# Access Compliance Report

## Public Rights-of-Way

Intersection ID: 12809	Main Street: N_MCDOWELL_ST	Cross Street: E_7TH_ST	Location: S
ADA ID: 12DE34372103	Ramp Type: PerpDiag	Initial Pass/Fail: Pass	Overall Compliance: No
Severity Score: 2.75			
Codes/Mitigation Info/Possible Solution		Field Measurements/Component Compliance

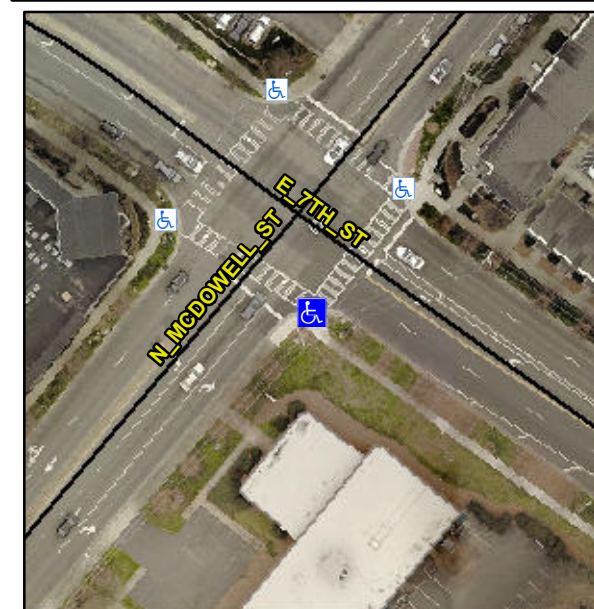
**Not Found, R304.5.3, R304.2.3**

Compliance	Description	Data	Compliance	Description	Data
N/A	Ramp Length (in)	89.0	Yes	Ramp Slope (%)	5.2
Yes	Ramp Width (in)	96.0	No	Ramp XSlope (%)	4.5
N/A	Flare Type LT	Sloped	N/A	Flare Type RT	N/A
N/A	Flare Slope LT (%)	10.4	Yes	Flare Slope RT (%)	3.0
N/A	Flare Traversable LT?	Yes	N/A	Flare Traversable RT?	Yes
Yes	Landing Length (in)	60.0	Yes	DWS Provided?	Yes
Yes	Landing Width (in)	60.0	Yes	DWS Contrast?	Yes
Yes	Landing Slope (%)	2.0	Yes	DWS Length (in)	24.0
Yes	Landing X Slope (%)	0.2	Yes	DWS Full Width?	Yes
N/A	Landing Curb? (Y/N)	No	Yes	DWS Offset (in)	0.0
N/A	Shared Landing?	N/A			
Yes	Gutter Ponding?	No	Yes	Gutter Slope (%)	0.7
Yes	Gutter Lip Ht (in)	0.0	No	Gutter X Slope (%)	4.0
N/A	Painted X Walk1?	Yes	N/A	Painted X Walk2?	Yes
	X Walk 1 Direction	To NE		X Walk 2 Direction	To NW
N/A	X Walk 1 Width (in)	111.0	N/A	X Walk 2 Width (in)	110.0
	X Walk 1 Slope (%)	5.3		X Walk 2 Slope (%)	3.3
	X Walk 1 X Slope (%)	4.5		X Walk 2 X Slope (%)	4.0

**Remove & Replace Curb Ramp With Two New Directional Ramps or Equivalent. Remove & Replace Gutter.**
